## Certificate of Appropriateness Case Report

*Filing Date:* December 13, 2018  
*Case No.:* **2018-016789COA**  
*Project Address:* **900 NORTH POINT STREET**  
*Historic Landmark:* No. 30 – Ghirardelli Square  
*Zoning:* C-2 (Community Business)  
40-X Height and Bulk District  
*Block/Lot:* 0452 / 026  
*Applicant:* Joshua Callahan  
Jamestown LP  
1700 Montgomery Street, Suite 110  
San Francisco, CA 94111  
*Staff Contact* Rebecca Salgado – (415) 575-9101  
rebecca.salgado@sfgov.org  
*Reviewed By* Tim Frye – (415) 575-6822  
tim.frye@sfgov.org

CERTIFICATE OF APPROPRIATENESS: APPENDIX  
REPURPOSED RESTROOMS

Section Detail (Scale: 1-1/2" = 1'-0")

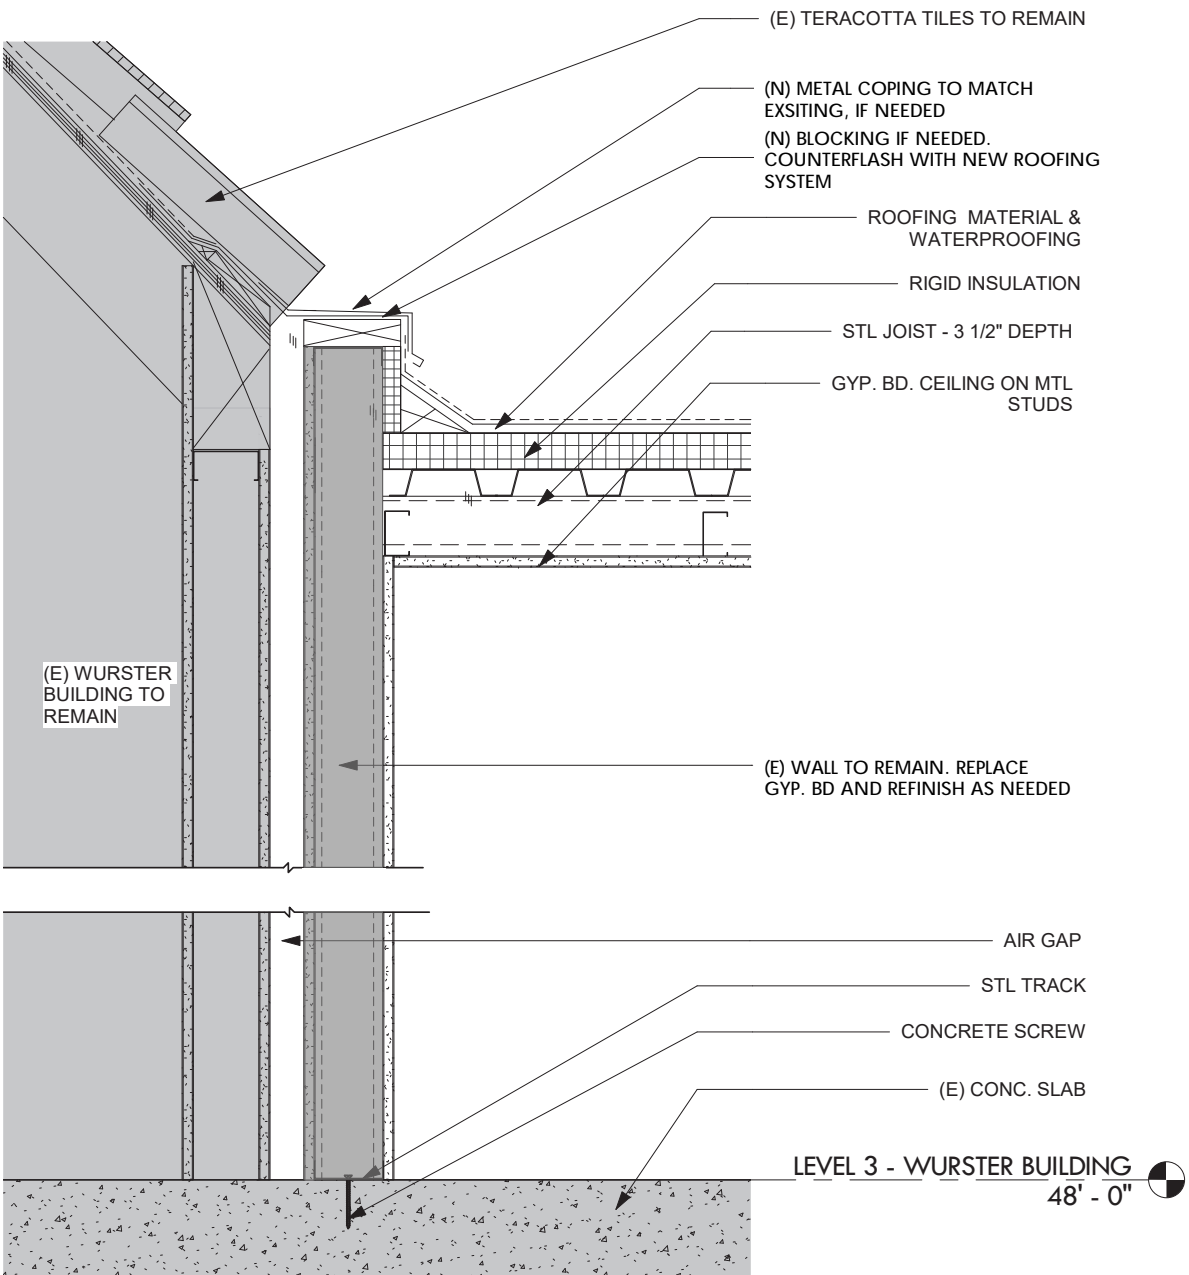
Generally, Staff found that the proposed scale and proportion of the new construction will be compatible with that of the landmark. However, in order to remedy rather than perpetuate an existing incompatible condition that exists at the Restroom Building where this building interacts with the Wurster Building, the Department recommended that the roofline of the new building be lowered or redesigned to allow the continuous line of the Wurster Building's roof eave to be restored and new terra cotta tiles to be installed where they had previously been removed. At the February 6, 2019, meeting, the Architectural Review Committee concurred with staff's assessment that restoring the historic roof eave would bring the project further in line with the Secretary of the Interior's Standards. However, the Committee determined that due to the specific conditions of this project, restoring the historic roof eave of the Wurster Building would not be the most feasible solution. The reasons the Committee gave against restoring the historic roof eave include the following:

As an alternate solution, the Committee proposed that the reconstructed roof detail be slightly modified to have a stepped fascia referencing the historic fascia of the nearby North Plaza Pavilion building. This stepped fascia would provide a more gradual transition from the addition's roof to the Wurster Building's clay-tile roof, and would also more closely reference the adjacent North Plaza Pavilion Building. The Committee also noted that this solution would also allow the reconstructed addition to more clearly read as a later addition to the historic Wurster Building, and avoid creating a false sense of history.

The proposed roof detailing is in response to the ARC's direction that the roof detail be slightly modified from an earlier, non-stepped proposal to instead have a stepped fascia referencing the historic fascia of the nearby North Plaza Pavilion building. The stepped fascia provides a more gradual transition from the addition's roof to the Wurster Building's clay-tile roof, and more closely references the adjacent North Plaza Pavilion Building. The differentiation between these two roofs allows the new building to read as a later addition to the landmark site, avoiding a sense of false historicism. The building's overall height will sit below that of the adjacent contributing buildings, to allow the addition to read as subordinate to the contributing buildings. The proposed rooftop mechanical unit will be located so as not to be visible from a public right-of-way. Overall, the proposed modifications to the Restroom Building are simple yet contemporary in design to differentiate these elements from the original building fabric, and also align with the Ghirardelli Square Design Guidelines.

1. As part of the Building Permit, the Project Sponsor shall provide material samples of the proposed brick cladding and storefront framing finish for review and approval by the Planning Department.
2. As part of the Building Permit, the Project Sponsor shall construct a mock-up of the proposed rooftop mechanical unit for review and approval by the Planning Department, to ensure that this unit will not be visible from a public right-of-way.
3. As part of the Building Permit, the Project Sponsor shall construct a mock-up of the proposed roof detailing at the area where the modified building interacts with the Wurster Building, for review and approval by the Planning Department.
